Title - Sujet Float and Guide Pile Installation	
Solicitation No. - N° de l'invitation EC373-172303/A	Amendment No. - N° modif. 002
Client Reference No. - N° de référence du client R.076365.001	Date 2016-12-20
GETS Reference No. - N° de référence de SEAG PW-\$PWB-030-4016	
File No. - N° de dossier PWB-6-39151 (030)	CCC No./N° CCC - FMS No./N° VME
Solicitation Closes - L'invitation prend fin at - à 02:00 PM on - le 2017-01-05	
Time Zone Fuseau horaire Atlantic Standard Time AST	
F.O.B. - F.A.B. Plant-Usine: <input type="checkbox"/> Destination: <input checked="" type="checkbox"/> Other-Autre: <input type="checkbox"/>	
Address Enquiries to: - Adresser toutes questions à: MacDonald (PWB), Charline	Buyer Id - Id de l'acheteur pwb030
Telephone No. - N° de téléphone (506) 851-6067 ()	FAX No. - N° de FAX (506) 636-4376
Destination - of Goods, Services, and Construction: Destination - des biens, services et construction:

Addendum No. 2

PIPE PILE – CATHODIC PROTECTION

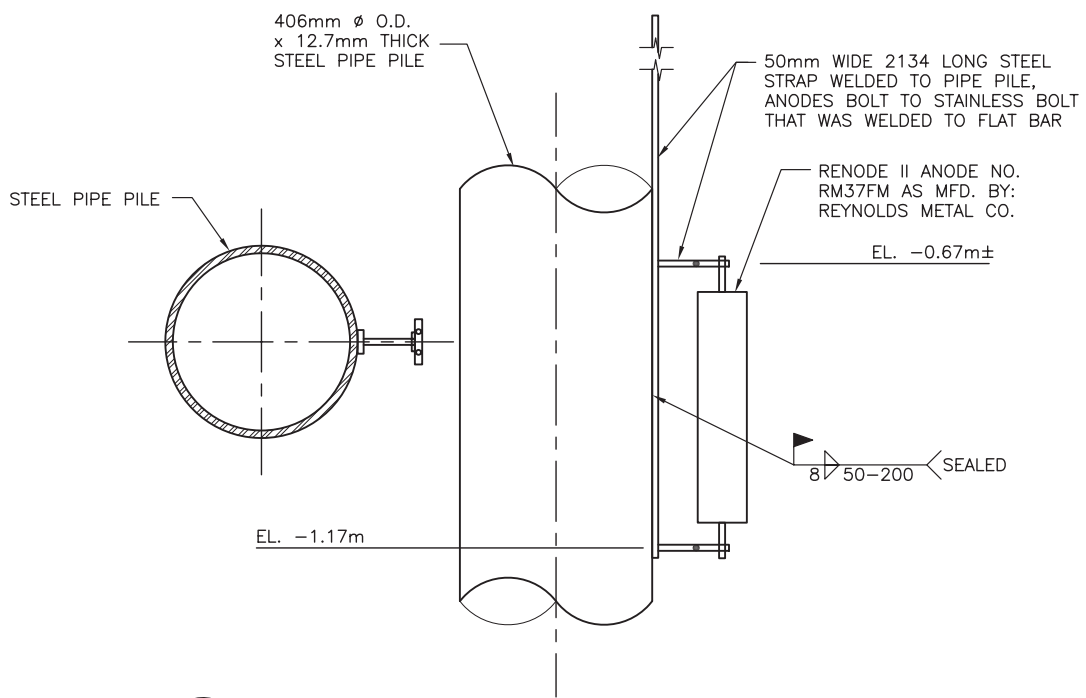
Q3: Are there any specifications or details of the cathodic protection for the steel pipe piles? Drawing M3 of 3 indicates the elevation of the anode but no welding details are provided.

A3: Please see attached detail.
